UNITED STATES PATENT AND TRADEMARK OFFICE

10/507,379

Office Action Summary	Application No.		Applicant(s)	
	10/507,379		YLITALO, JARI	
	Examiner		Art Unit	
	Paul Ip		2837

DETAILED ACTION

Fig. 3.

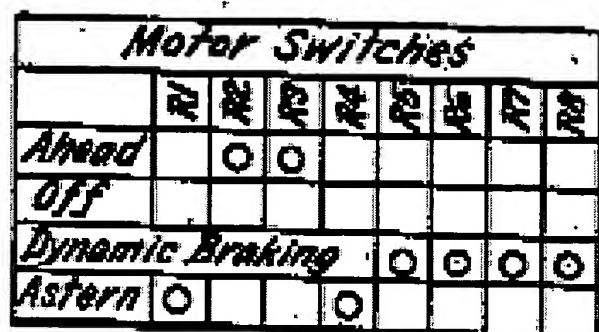
The patent to Frisch shows in figure 3 the motor switches off when the dynamic braking switches are connected to the resistors.

Kilgore does not clearly specify disconnect the electrical power network. However, the patents to Schmucker et al and Frisch disclose disconnect the electrical power network during dynamic braking and before reverse the motor direction. Prima facie case is made that Kilgore disclosed the switch 20 can be closed with frequency converter 22 set to output a frequency equivalent to that of the generator and the generator 12 can then be electrically disconnected from the motor 16 by opening switch 18. When performing the dynamic braking of a motor, one of ordinary skill in the art would disconnect the motor from the electrical power network in order to prevent the electrical power network damage during the dynamic braking. One of ordinary skill in the art would disconnect Kilgore's electrical power network from the motor as taught or suggested by Schmucker et al or Frisch to prevent the damage of the electrical power network during the dynamic braking.
